STAFF RECOMMENDATION

1511 Russell Street

Application: New Construction—Infill

Description of Project: Construct infill house to replace house demolished after the March 3, 2020 tornado.

A100

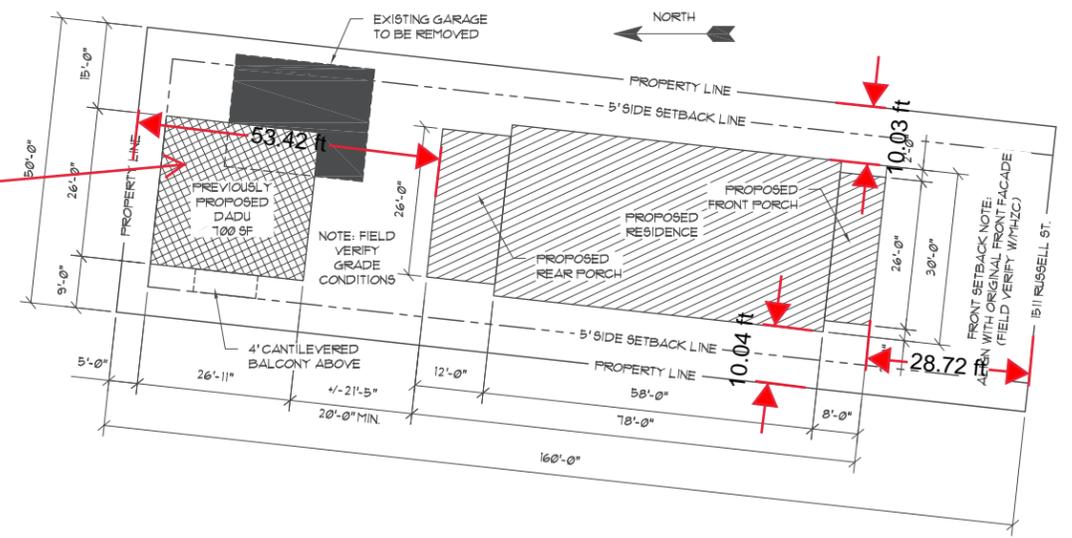
Setback & Rhythm of Spacing: The proposed infill meets all setbacks. The front setback is proposed at approximately (28'-9") from the front property line, which matches the front setback of the historic house that was demolished. The proposed infill is located approximately ten feet (10') from both side property lines and approximately fifty-three feet (53') from the rear property line. The rear of the infill is twenty-one feet, five inches (21'-5") from the front of the approved outbuilding.

Orientation: The house will be oriented to Russell Street and will have a centered partial-width covered front porch with a depth of eight feet (8’). While a walkway to the front sidewalk is not indicated on the plan, one remains from the previous house.

4. Prior to issuance of a preservation permit, the site plan shall include a walkway from the front porch to the public sidewalk; and
5. The HVAC be located behind the house or on either side, beyond the mid-point of the house.

A103

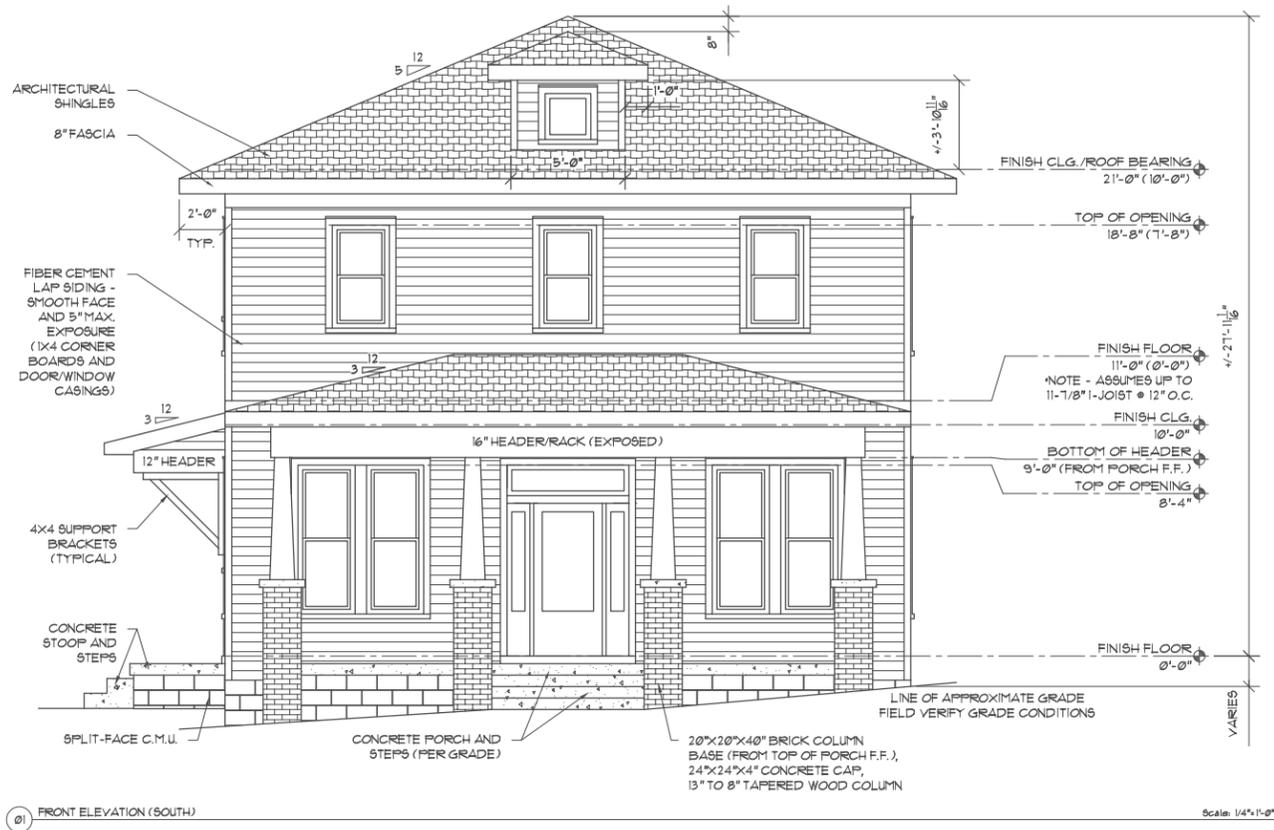
Height & Scale: The proposed infill is two stories with a height and scale that are comparable to the historic house that was damaged by the storm. The infill has a height of approximately twenty-seven feet, eleven inches (27'-11") from grade and a width of thirty feet (30'). Surrounding historic houses on comparably sized lots are one or one-and-a-half stories and between about twenty-three to twenty-nine feet (23'-29') tall with the taller homes exhibiting a pyramidal roof form. While the remaining historic context on this block of Russell Street does not include other examples of two-story historic homes, staff finds the proposed height and scale to be appropriate for this lot since the

Roof form: The primary roof form of the infill is hipped with a 5/12 pitch. Although the guidelines call for a minimum of 6/12, a lower slope is common for hipped roofs of two-story buildings. The front and rear porches also have a hipped roof form but with a 3/12 pitch that is appropriate for porch roofs. The rear porch is two-stories.

The project incorporates a small front dormer with roof form and pitch to match that of the house. As proposed, the dormer is set in only one foot (1’) whereas the design guidelines state that dormers should be set in two feet (2’) from the wall below. However, staff finds that the one foot (1’) inset can be appropriate in this case since the combination of the dormer’s small size at only five feet (5’) wide, its location eight inches (8”) off the ridge, and its appropriate roof form, combined help to create the appearance of an appropriately scaled dormer.

Proportion and Rhythm of Openings: The primary windows on the proposed infill are all generally twice as tall as they are wide, thereby meeting the historic proportions of openings. There are no large expanses of wall space without a window or door opening.

A104

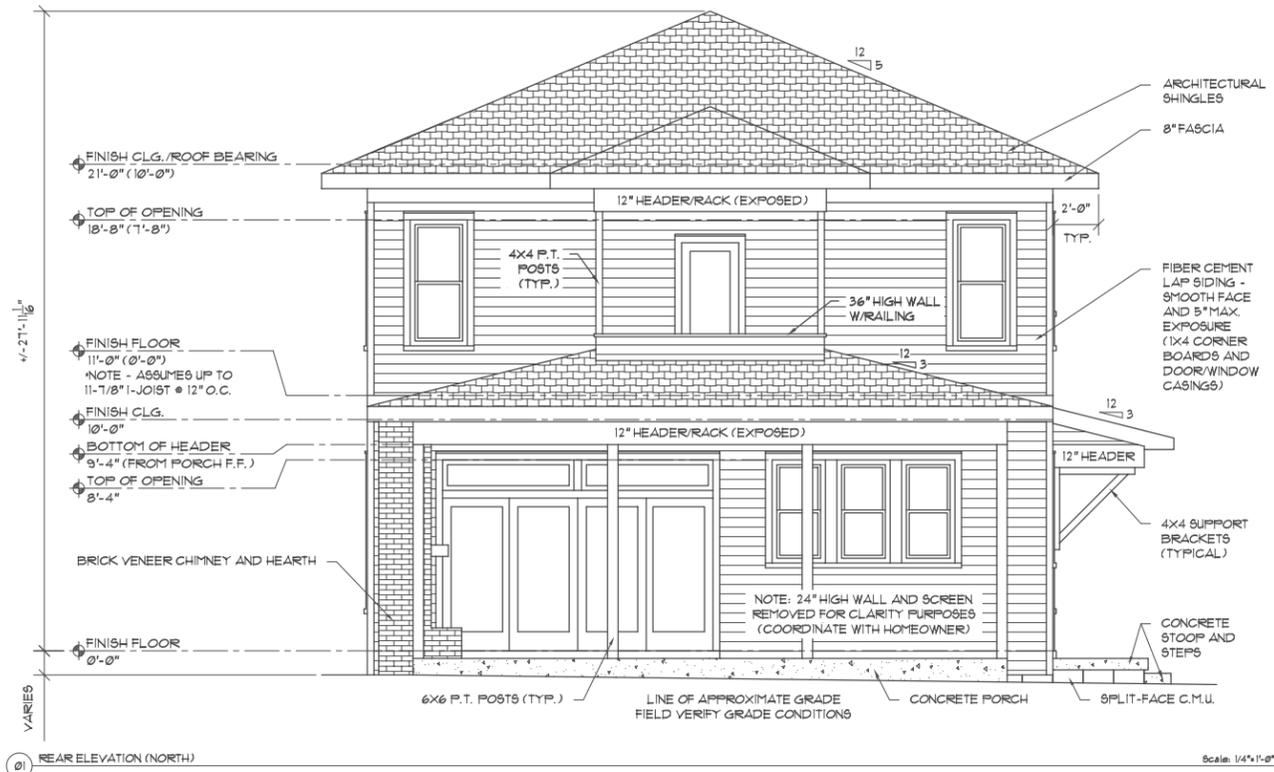
Appurtenances & Utilities: The location of the HVAC and other utilities was not noted. Staff asks that the HVAC be located on the rear façade, or on a side façade beyond the midpoint of the house.
